INDESIT company

Model type:
LI640A

Commercial code:
F029512

n1045069: Modification of racks and dispenser lid on EVO3 dishwashers

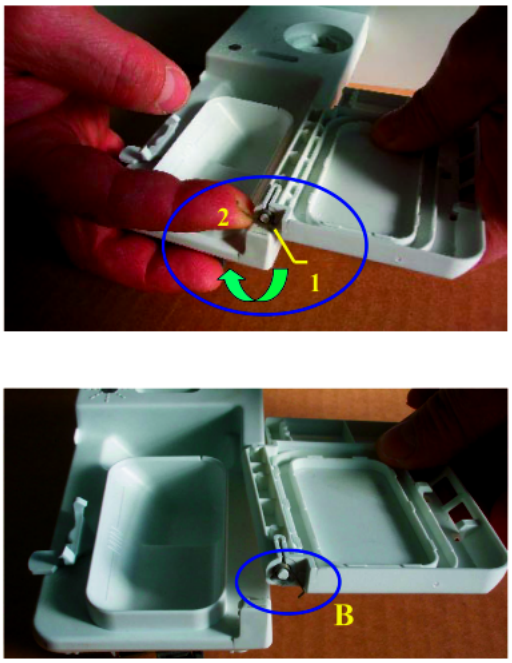
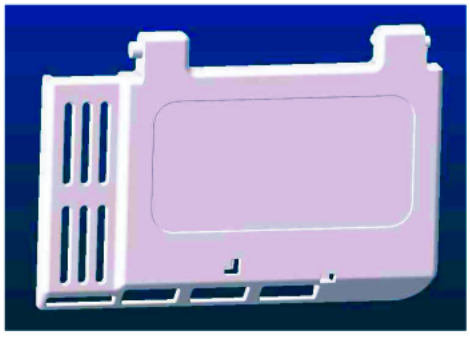
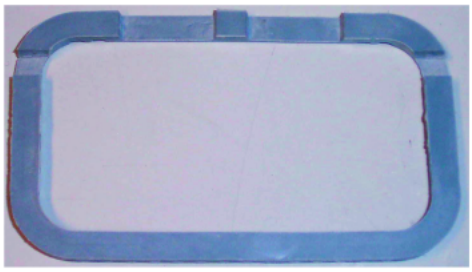
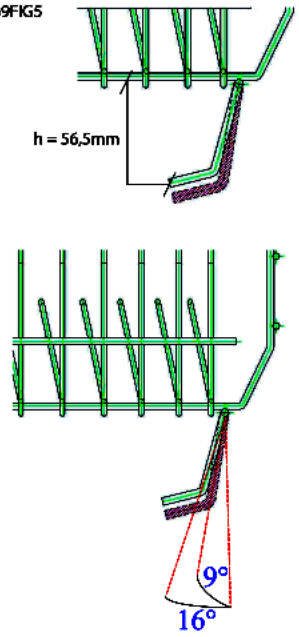
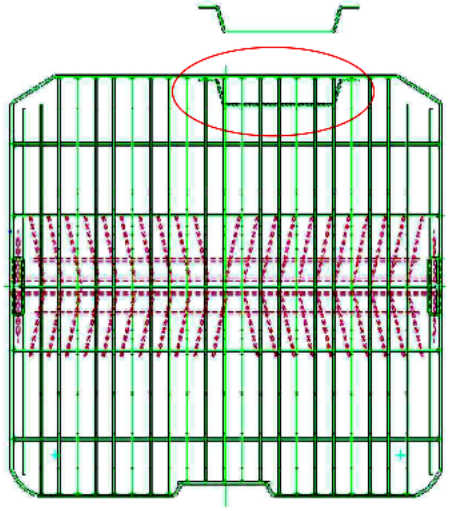
To obtain better dissolving of the detergent during the wash cycle, the following modifications have been made to EVO3 dishwashers:
- new dispenser lid, replacement code 098134 (see figure N1045069FIG4) created;
- upper racks modified with lid catch angle changed from 9° to 16° (see figure N1045069FIG5);
- MultiSystem lower racks modified with insertion of a spacer wire at the electric dispenser (see figure N1045069FIG6).

Lid installation instructions:
1) prise the lid out of the dispenser seat using a small screwdriver at point A (figure N1045069FIG1);
2) replace the lid, checking that release spring B (figure N1045069FIG2) is in place; before fitting the new lid load the spring from position 1 to position 2 (figure N1045069FIG2);
3) fit the lid in its special seat and check for correct operation (figure N1045069FIG3).
Lid closing may be harder for the first few cycles after replacement, due to settling of the material.

The upper and lower racks have the same spare part codes as the premodification items; Replacements Warehouse stocks have been replaced.

N1045078FIG1

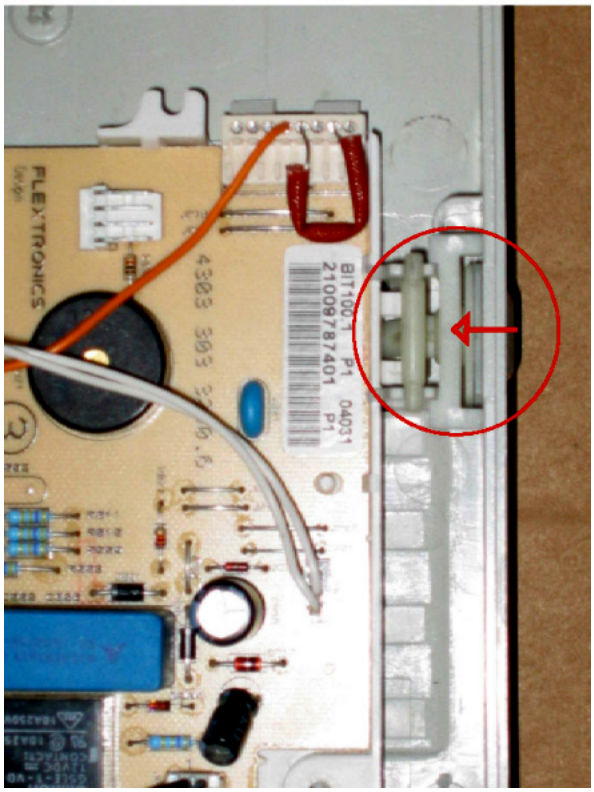
From serial no. 40406.0001, all dishwashers affected by this note have been equipped with a distance plug Service code 109844 in order to improve the mechanism of the "P" programme button (see N1045078FIG1).

N1045083FIG1

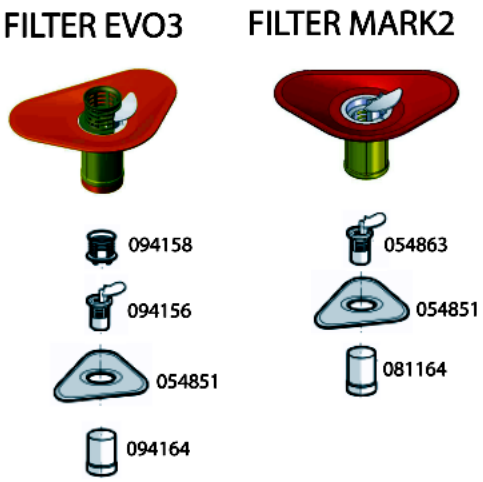
All dishwasher models affected by this modification have been equipped with the items listed below, in order to solve the drain pump clooging problem.

Introduction of:
Cylindrical plastic filter code 081164
Central filter code 054863

Elimination of:
Cylindrical plastic filter code 094164
Central filter code 094156
Central filter grid code 094158

The modification has been introduced progressively, starting from serial no. 40516.0001.

n1045085: Introduction of new litre counter turbine integrated on air-break.

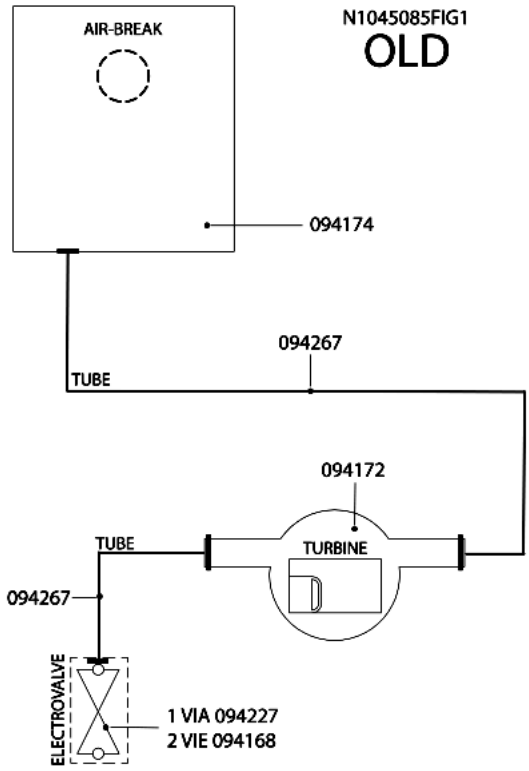
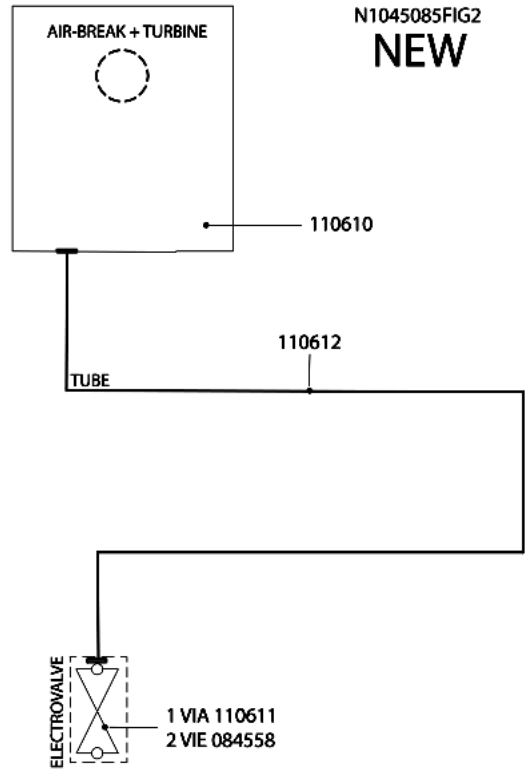
All dishwashers affected by this note have been equipped with a new litre counter turbine on the air-break.
Picture N1045085FIG1 illustrates the premodification structure, picture N1045085FIG2 the new structure.

AIR-BREAK:
new 110610;
premodification 094174;
the new item features a new integrated litre counter turbine and its water supply hose has a smaller diameter.

LITRE COUNTER TURBINE code 094172 has been eliminated.

SOLENOID VALVES:
new:
1-WAY code 110611;
2-WAY code 084558(Rohs 143737);
premodification:
1-WAY code 094227;
2-WAY code 094168;
the new solenoid valves have a smaller diameter drain hose fitting.

HOSES:
new solenoid valve hose/air-break code 110612;
premodification turbine hose/air-break code 094267;
premodification solenoid valve hose/air-break code 094267;
the new hose has a smaller internal diameter.

WIRING:
the litre counter turbine connecting cable is longer, but since the connector is the same, the new item can be used in place of the premodification one.

N1045093FIG1
NEW FLAP UPPER BASKET SAT CODE 114799

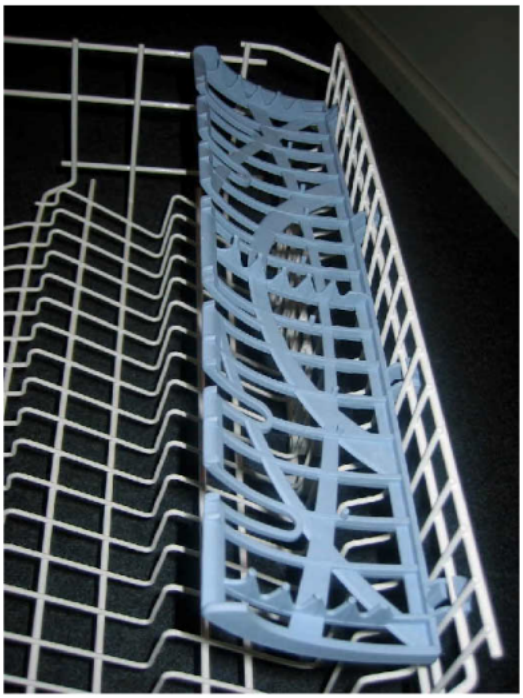
From serial no. 41109.0001 all models affected by this bulletin feature a modification of the folding shelf to upper basket coupling system.
This modification called for alteration of the relative baskets: the distance between the wire on which the folding shelf is attached and the wire below it has been increased from 9.5 mm to 17 mm, as shown in the attached image.
The altered folding shelves are not interchangeable and cannot be installed on premodification baskets: in the case of service interventions on product with serial number prior to 41109.0001 the entire upper basket must be replaced.
The baskets are reciprocally interchangeable and are managed as assemblies complete with their accessories, inclusive of folding shelves.

UPPER BASKET LIGHT BLUE FOLDING SHELF
new 114799 - premodification 094140.

UPPER BASKET ASSEMBLIES
new 115001 - premodification 094139;
new 115002 - premodification 094222;
new 115003 - premodification 094233.

n1045127: New airbreak - solution of water spurts leaking from base LVS 60 CM

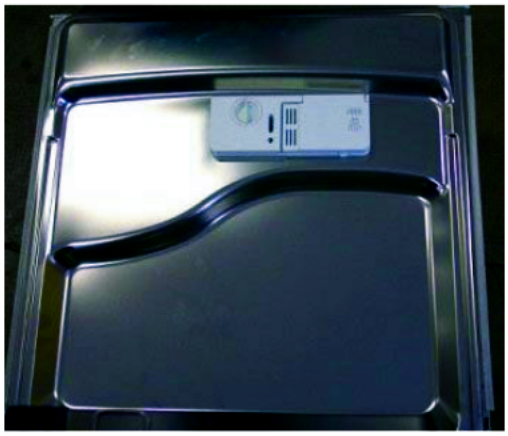
From serial number 50930.0001, to solve the problem of water spurts emitted from the lower right and left side of the door the following modifications were introduced in production:

1-Airbreak without insert to allow the necessary pressure venting
2-Honeycomb top panel to protect the kitchen unit from any steam emitted (only on built-under models)
3-Tank seal length increased by 3 cm to improve water tightness
4-Die-cut roof sound-deadening panel
5-Three clips for correct fixing of the tank base seal (in production from serial number 50701.0001)

New parts:
C00141308 - Airbreak
C00141310 - Honeycomb top panel (built-under versions only)
C00141317 - Tank seal
C00141314 - Roof sound-deadening panel
C00140679 - Tank base seal fixing clip

Premodification parts
C00110610 - Airbreak
C00116110 - Tank seal
C00097300 - Roof sound-deadening panel

1) AIRBREAK REPLACEMENT
It is mandatory to use the new part; in the event of replacement with premodification appliances proceed as follows:
- replace the airbreak with the new part C00141308
- if present, refit the roof sound-deadening panel after cutting out a 10x10 cm square from the rear left-hand corner
- on the built-under version, fit honeycomb panel C00141310 on the top of the appliance
- replace tank seal with the new seal P/N C00141317

WARNING: when replacing an airbreak without a litre-counter turbine use exclusively the same type of part (P/N C00094174 - all the relevant details are given in bulletin n1045085)

2) CHANGING THE TANK SEAL
On appliances with serial number from 40101.0001 to 50930.0001, you can use the new tank seal P/N C00141317 after cutting 1.5 cm off each end.

N1045133/134FIG1

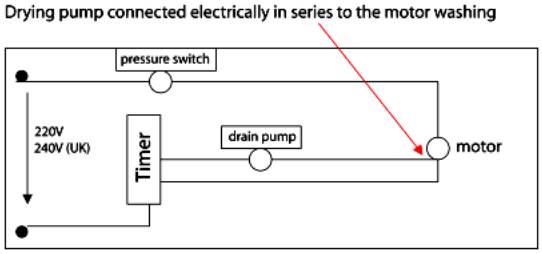
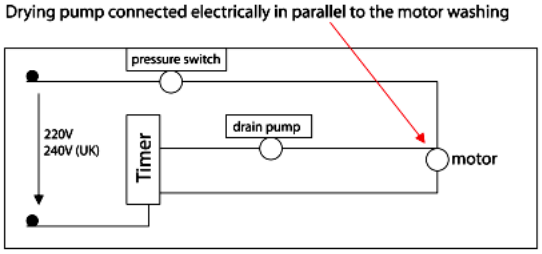
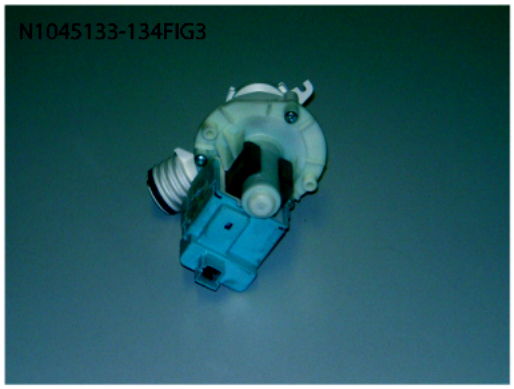
The drain pump electrical connection has been modified from a configuration in series with the wash electric pump to one in parallel.

The drain pump in series with the wash electric pump is fed through the wash electric pump causing a voltage drop equal to -15V (diagram N1045133-134FIG1).

The drain pump in series with the wash electric pump is electrically fed directly by the F-N line, without any voltage drop (diagram N1045133-134FIG1).

New parts:
Wiring in parallel
C00118767(Rohs 143766) - thermoprotected drain pump 220/240V 50HZ 26W - picture (N1045133-134FIG3)

Premodification parts:
Wiring in series
C00112306(Rohs 143739) - drain pump 230V 50HZ 22W - picture (N1045133-134FIG4)

Important!!
The thermoprotected drain pump cannot be installed on premodification dishwashers.
The non-thermoprotected drain pump cannot be installed on modified dishwashers.

n1045136: introduction of new high pressure sensor

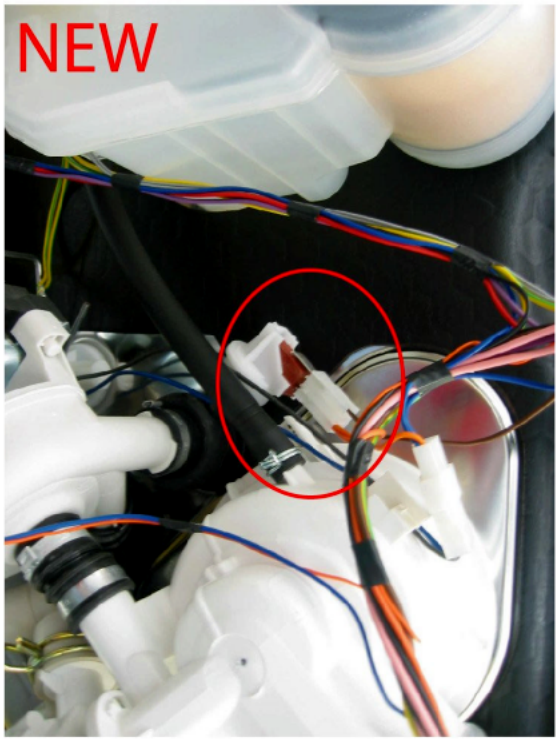
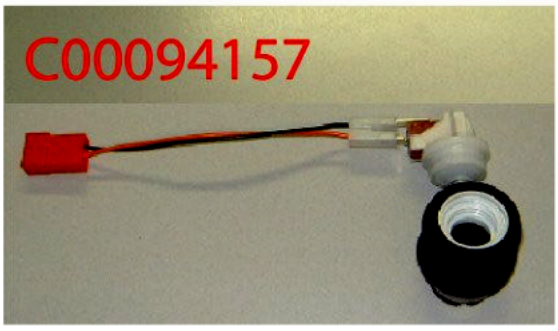
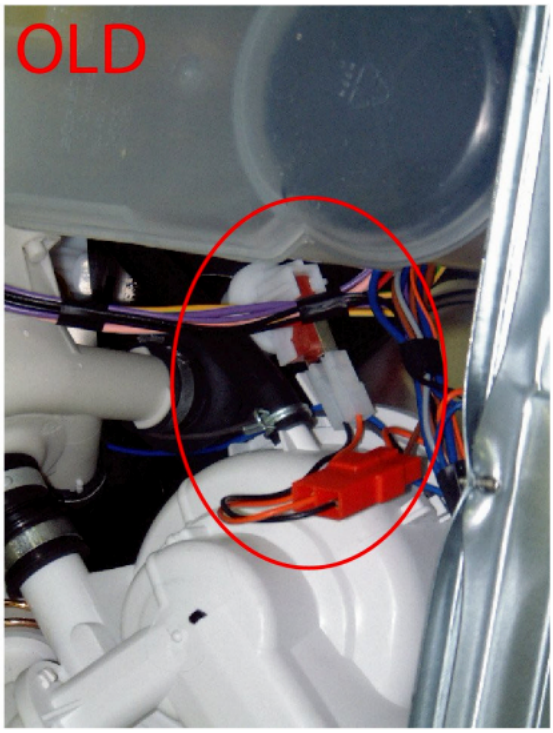
In modified products the connector going to the high pressure sensor is part of the wiring assembly (see picture N1045136FIG1).
In premodification products the high pressure sensor is connected to the wiring assembly by a cable that is part of code C00094157 (see pictures N1045136FIG2-3).

New parts
Wiring
C00142435 - high pressure sensor

Premodification parts
Wiring
C00094157 - high pressure sensor + cable

The new parts are not individually interchangeable with premodification ones.
